SIERRA GEOTECHNICAL SERVICES INC.

Subject: **RESPONSE TO PEER REVIEW**
Phase 2 of Tentative Tract 37-46
White Mountain Estates Subdivision
Chalfant Valley, Mono County, California

Reference: Review Of Earthquake Fault Zone Hazard Evaluation Reports
Tract 37-16 And Phase 2 of Tentative Tract Map No. 37-46
White Mountain Estates Subdivision
Chalfant Valley, Mono County, California
Prepared by AMEC Earth & Environmental dated January 12, 2006

GEOLOGIC LOG OF DEEPENED TRENCH T-5
SHEETS 1 – 7 OF 7

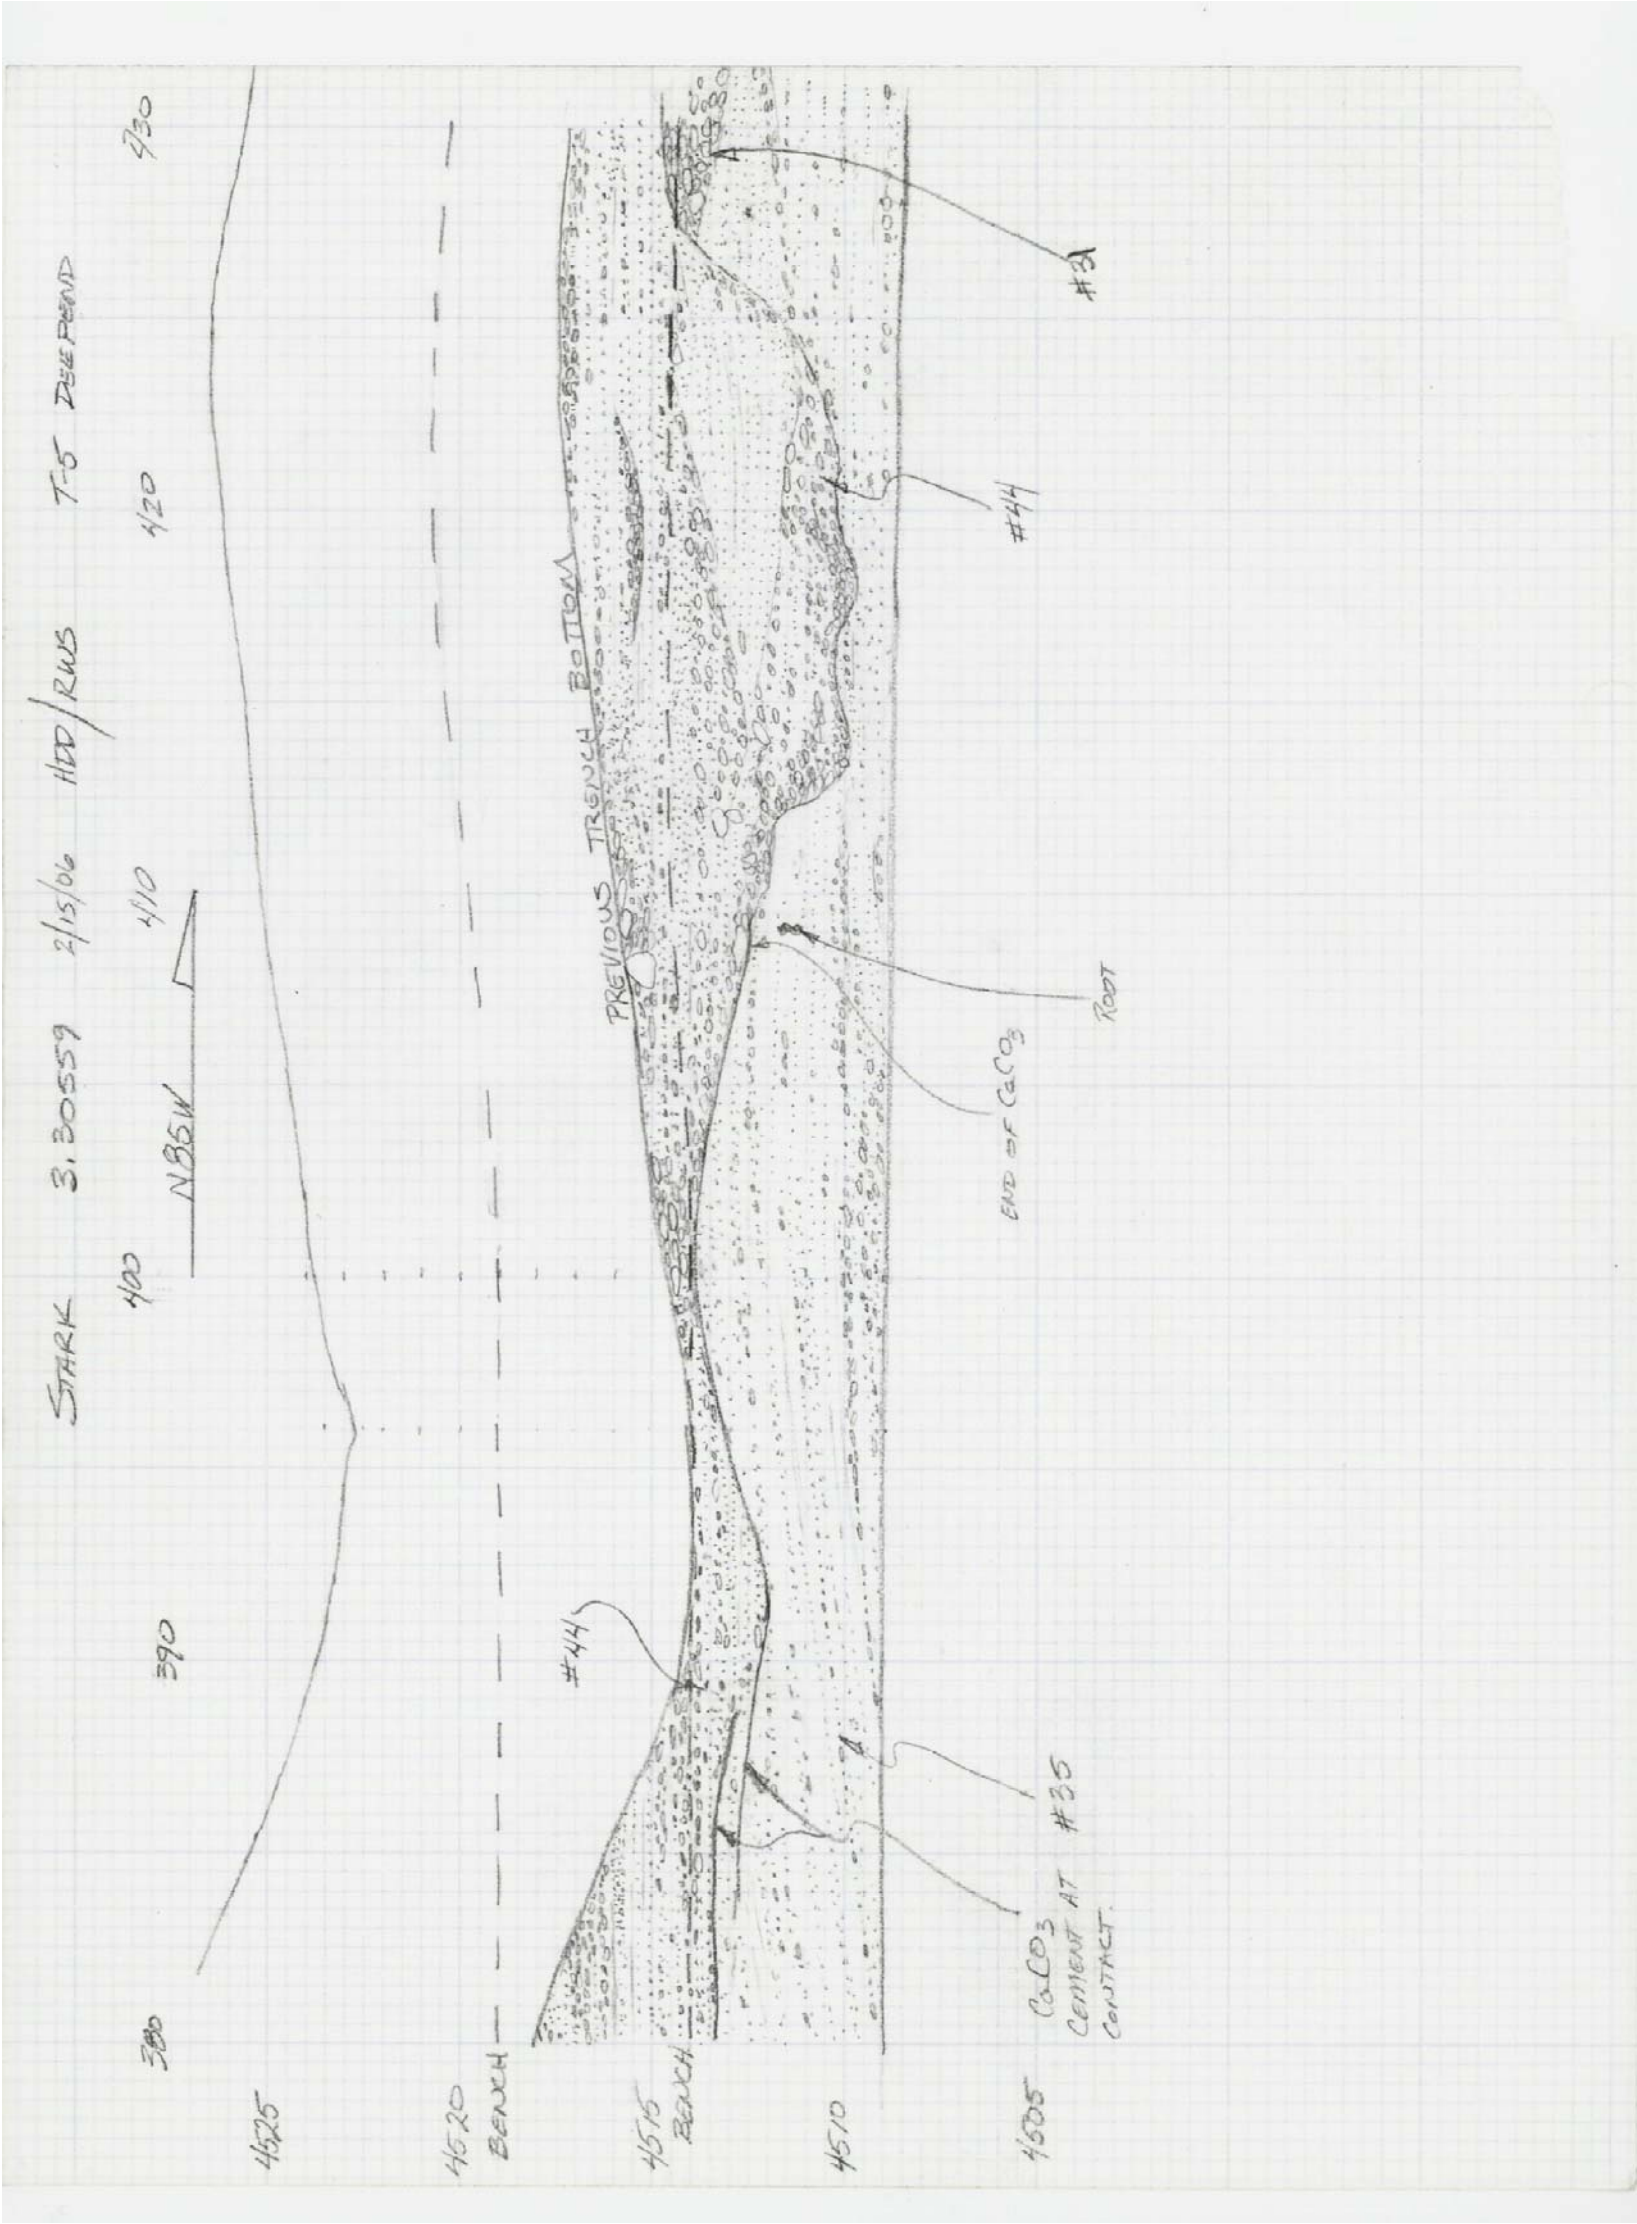
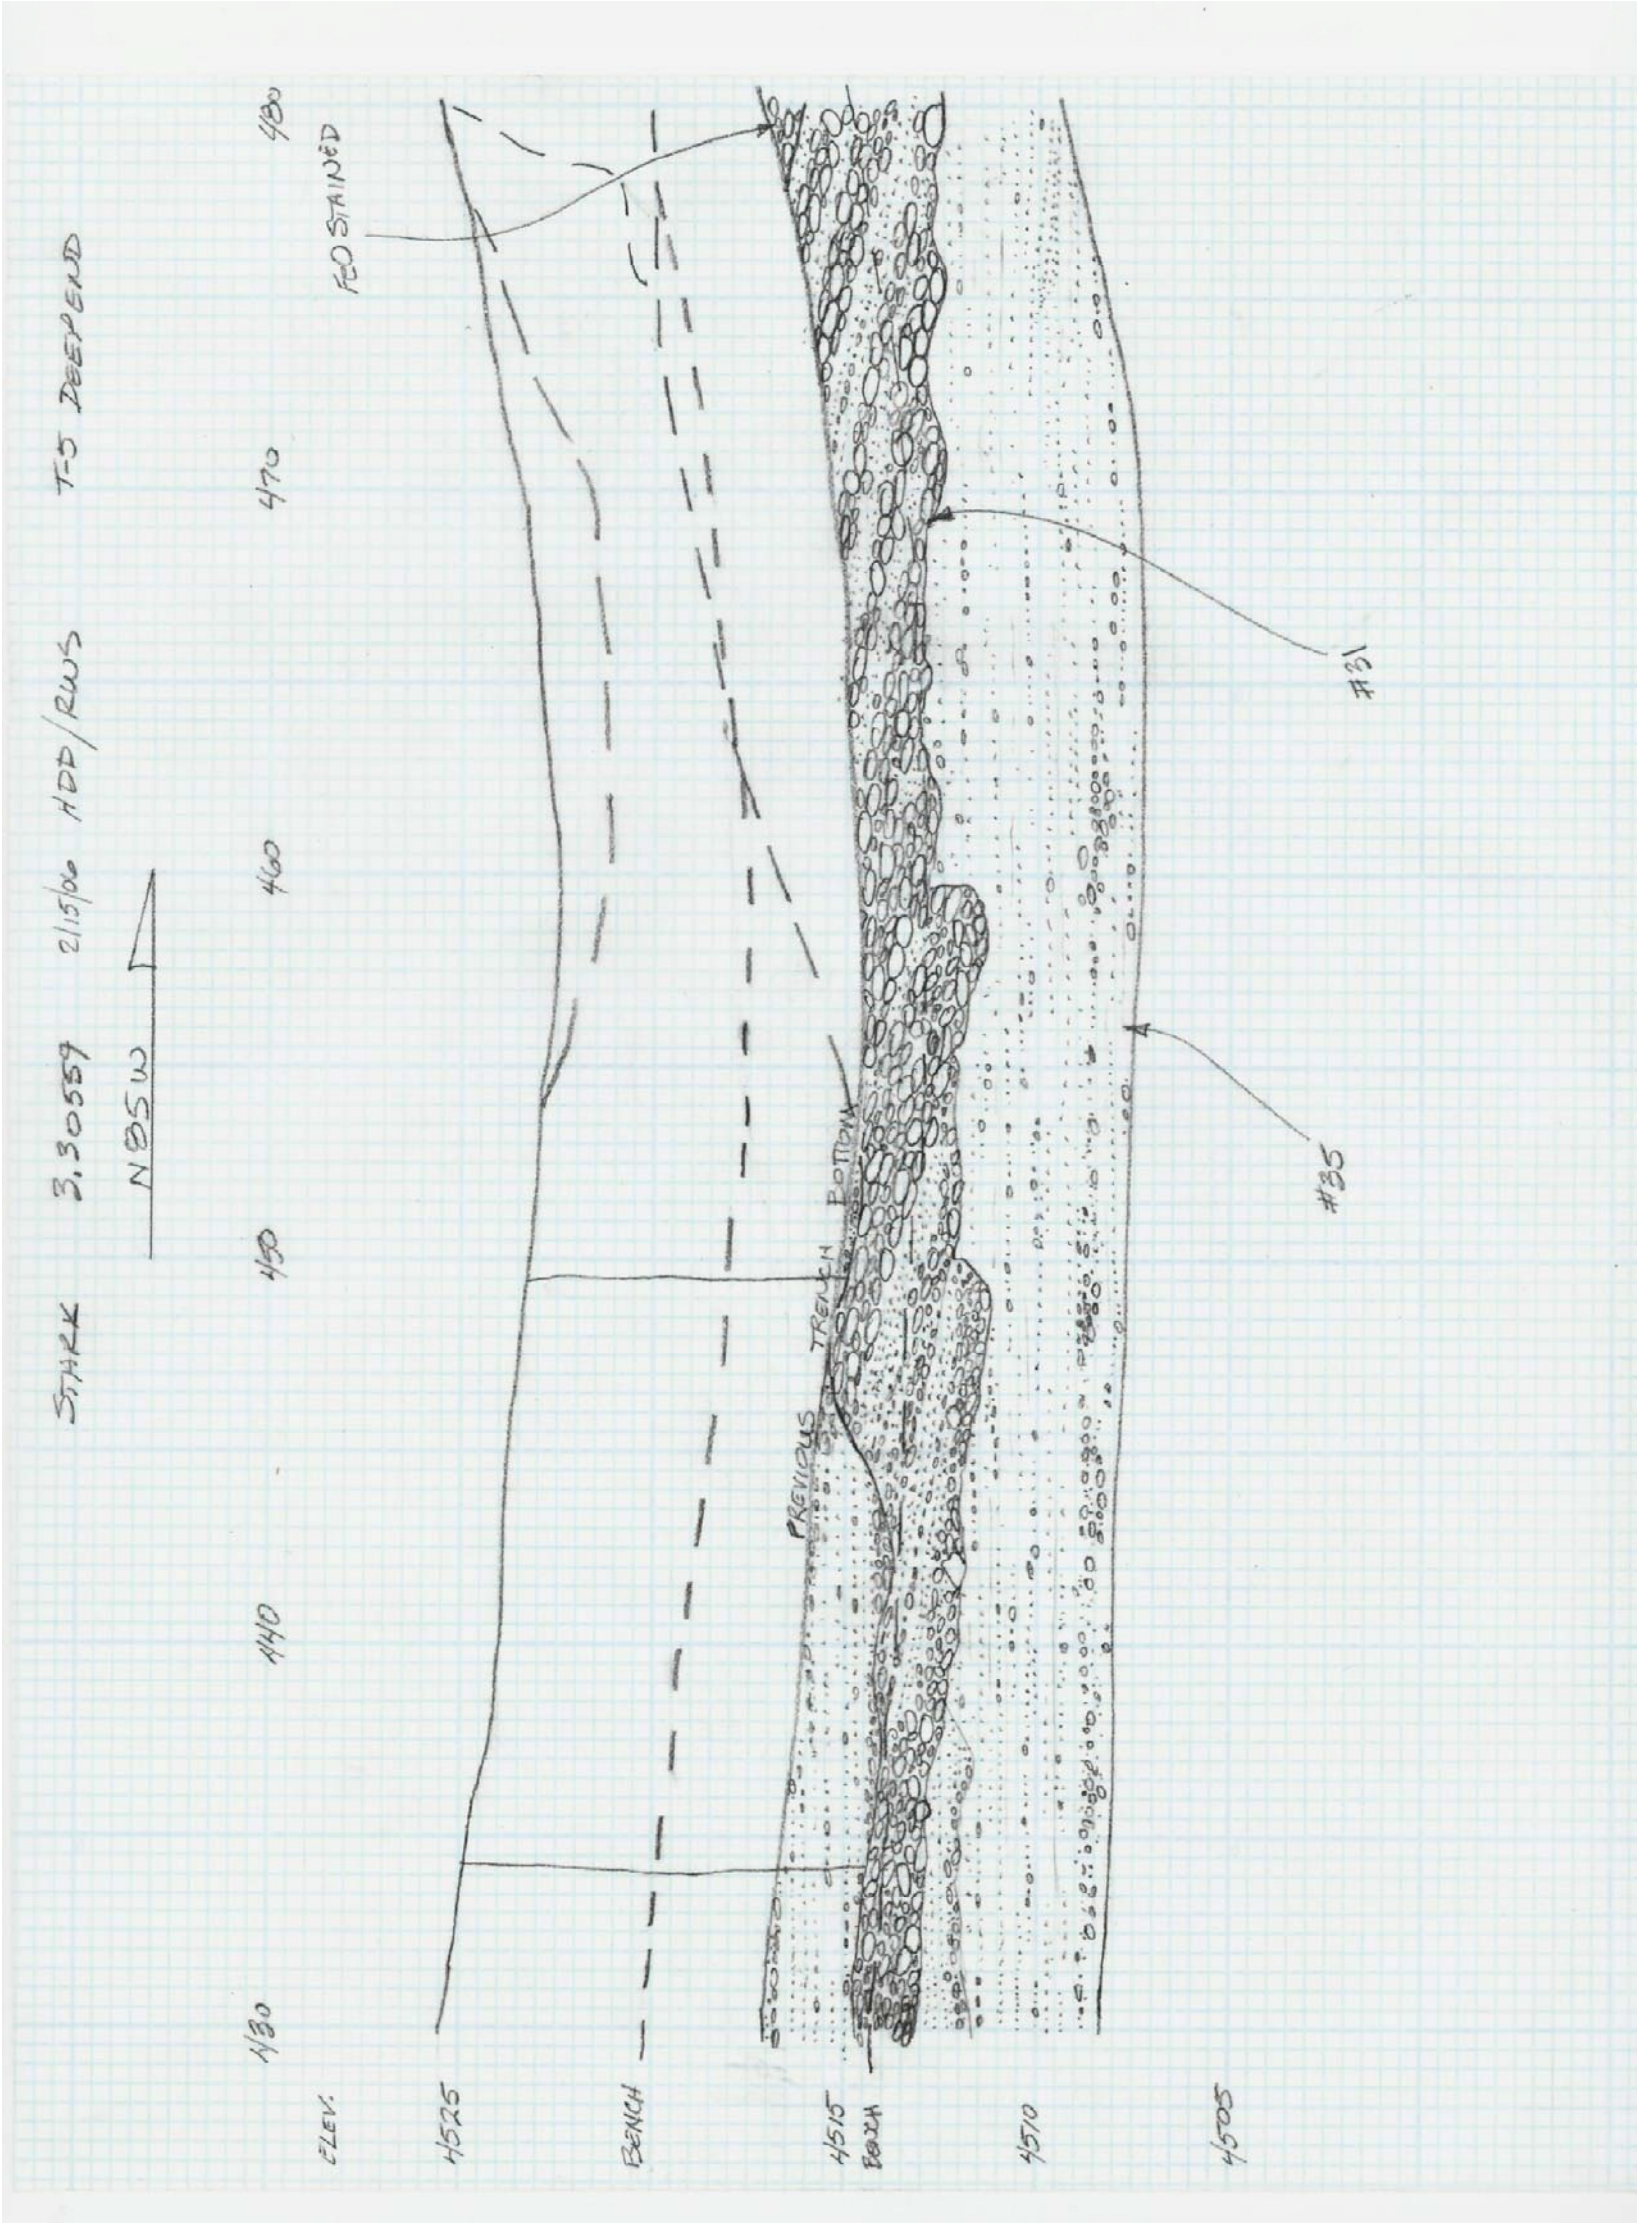
The designated habitable areas within Lot 45 are based on the fault related features and their structural orientations as observed and subsequently depicted in the logs of Trenches T-5 and T-6. The geomorphic features mapped within Lot 45 have been designated as Qfy (2), Qfi (3/4) and Qfo (6) having respective ages varying from Holocene to Middle-Early Pleistocene as previously determined by Bruce Schell. The alluvial sediments exposed in the fault Trench T-5 and T-6 are described by SGSI as being recent to late Pleistocene in age. The designated habitable areas within Lot 45 are depicted as two triangular shaped areas that are approximately 140 [feet] wide at their widest point. The easterly most area is situated on uplifted and eroded terrain associated with the Qfo (6) alluvial terrace surface. The proposed habitable area to the west is situated on recent alluvial deposits principally within an active drainage course.

The easterly 340 [feet] of Trench T-5 is situated within terrain that has been mapped as Qfo (6). A significant portion of these alluvial deposits appear to have been cut by active faults. The only portion that appears to have been unaffected is the roughly 35 [foot] wide section between Stations 2+88 and 3+23 that is inclined at a gradient of approximately 29 percent. This area may (sic) not be large enough to be considered buildable particularly when considering its narrow shape and the steepness of the existing ground surface.

The westerly portion of Trench T-5 from Station 3+40 to 5+26 is largely underlain by recent alluvial deposits. The contact at the base of the Holocene alluvial sediments has not been exposed over most of this portion of Trench T-5 and as such a definitive statement regarding the active faulting cannot be made by the project consultant. Based on these conditions it is recommended that the proposed habitable [area] associated with the westerly portion of Trench T-5 not be accepted without deepening of the trench to expose the full section of Holocene alluvial fan deposits, from the contact with the underlying Pleistocene alluvium to the ground surface, that are unaffected by fault features. The project consultant should also consider the buildability of this area considering the potential for flood related issues as this area is largely situated in an active drainage course.

Response: In conformance with the recommendation provided in the comment above, Trench T-5 was re-trenched to expose the full section of the Holocene alluvial fan from the ground surface down to its contact with the underlying older Pleistocene alluvium. Deepened Trench T-5 was also extended west for an additional 155 feet to Station 7+00. Based upon our observations and logging of the deepened exposure, active faulting was not observed in the older deposits between Station 3+40 through 5+26. This find is not consistent with the faults found in Trench T-6 to the south. An effort was made to crosscut the faults projecting northward from Trench T-6 in order to account for the lack of faulting observed in deepened Trench T-5, but this could not be accomplished. Instead, both the geologic log of Trench T-6 and the geomorphic expression of the topography surrounding Trench T-6 were re-interpreted to be a landslide, which accounts for the lack of faulting in deepened Trench T-5. Landslide features are observed in Trench T-6, and they include a buried head scarp at Station 2+90, a backfilled graben between Stations 2+90 and 3+85, back-rotated landslide blocks between Stations 3+85 and 5+10, and basal slide planes near the landslide toe between Stations 5+10 and 5+38. Geomorphic landslide

features are also observed in the topography that surround Trench T-6, and they include a steepened slope at the landslide head, two re-entrant gullies ascending up to the landslide head from the drainage on the north and from the drainage on the south, and “over-steepened” slopes on both hills that ascend from where these drainages converge, which is the same location where the landslide came to rest. The landslide has been somewhat modified and “melted” by cumulative erosion over time, but the geomorphic features are still substantially preserved.

Active faulting was observed at the westernmost extent of deepened Trench T-5 from Station 6+80 to 7+00. This observation is a better fit for Significant Fault No. 3, which projects north from the westernmost extent of Trench T-6. It is interpreted that this east-dipping fault provided the mechanism by which movement occurred along the toe for this landslide. Therefore, based on the new data observed in deepened Trench T-5 our new interpretation for the landslide in Trench T-6, and the potential for flood related hazards from the drainage, the proposed habitable areas on Lot 45 have been revised, and they are delineated on the Revised Geologic Map.
